APPLICATION NO.	FILING DATE	FIRST NAMED INVENTOR	ATTORNEY DOCKET NO.	CONFIRMATION NO.
10/588,402	08/03/2006	Gunther Flattinger	FLATTINGER ET AL - 1 PCT	6943
25889	7590	11/24/2010	EXAMINER	
JENNISON, BRIAN W				
COLLARD & ROE, P.C. 1077 NORTHERN BOULEVARD ROSLYN, NY 11576			ART UNIT	
			PAPER NUMBER	
			3742	
			MAIL DATE	
			DELIVERY MODE	
			11/24/2010	
			PAPER

Office Action Summary

2. **Claims 51-58, 60-63, 65, 67-68, 70-79, 80-84, 87-89 stand rejected under 35 U.S.C. 102(b) as being anticipated by Kensrue.**

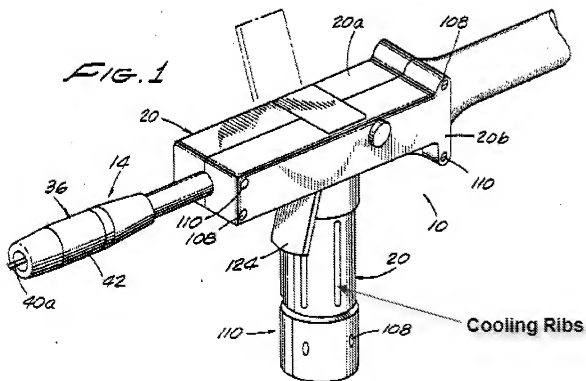
In response to applicant's argument on page 3 of the reply regarding Kensrue not teaching the part of the torch housing being the stator housing, the figure below clearly shows two parts of the housing, which are not required to be separate, that make up a welding torch housing with part of the housing being a stator housing. There are no limitations as to what constitutes a stator housing, it could be any part of the torch housing such as the right rear corner. The phrase "a part of the torch housing represents the stator housing of the drive motor..." is merely an arbitrary phrase describing an unspecified part of the torch.
